Item No. 45-6
Mr. Poturalski
Date: 2/19/04

PROPOSED NEW STANDARD DRAWINGS

802-SNCS-01, Cable Span Sign Structure Details

STANDARD DRAWING NO. E 802-SNCS-01

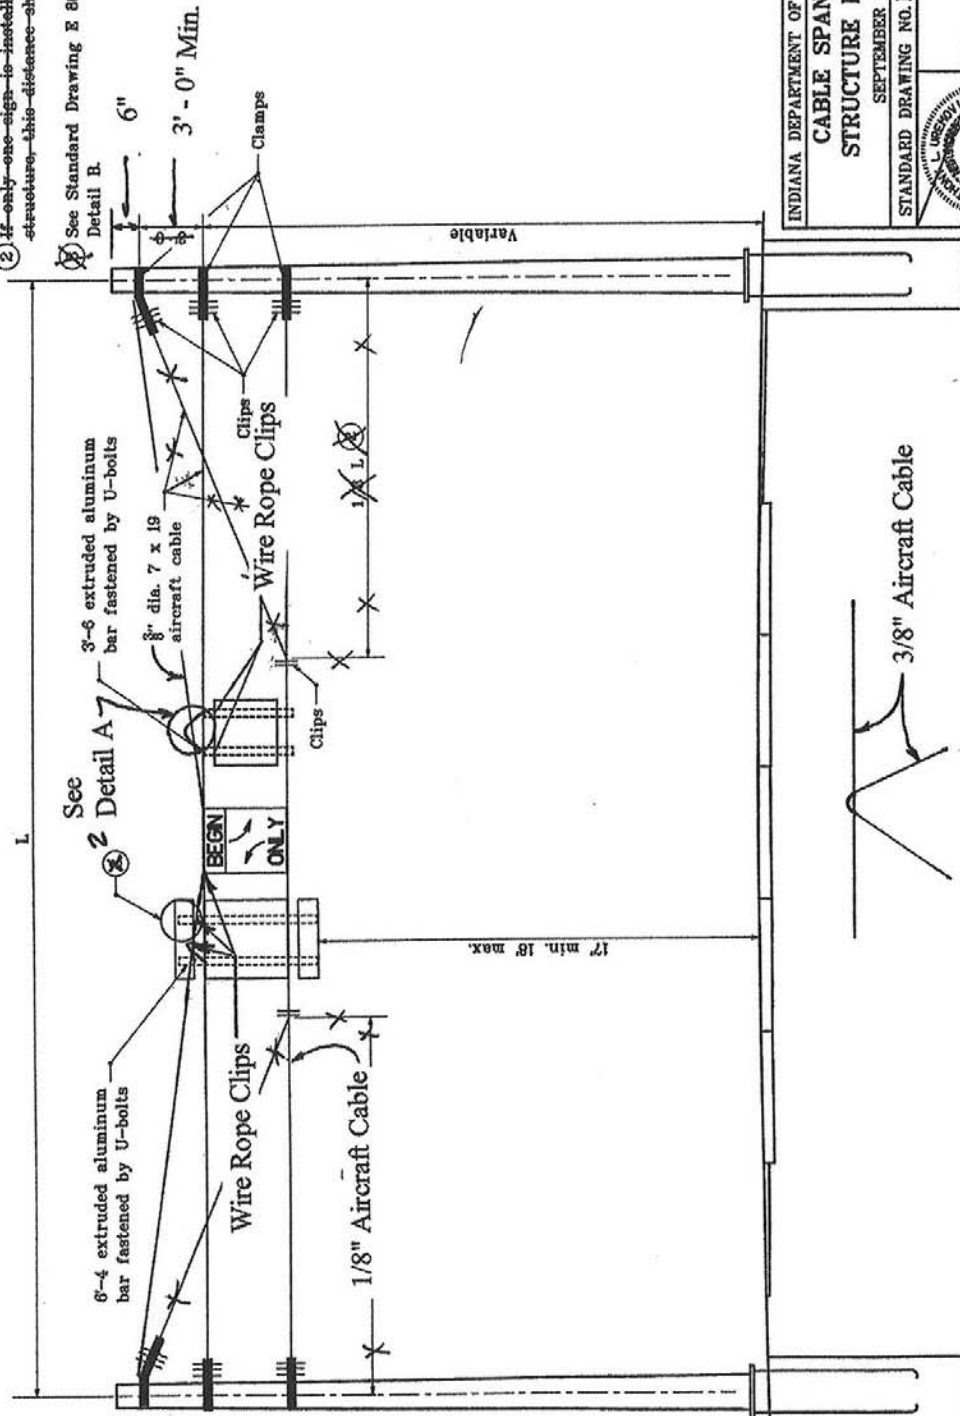
The intent of this proposal is to solve the sagging and buckling problem we are seeing in our overhead cable spans. This change would make them identical to our signal plan standard.

4. CLIPPED WASHER DETAIL

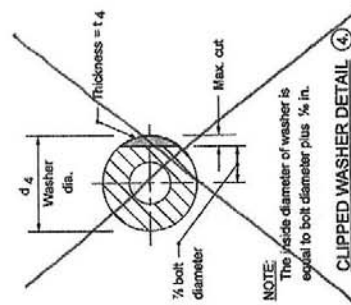
The proposed change was overlooked on a previous set of standard changes dealing with panel sign installation. Due to previously approved changes, the clipped washer is no longer needed. Standard washers are now appropriate.
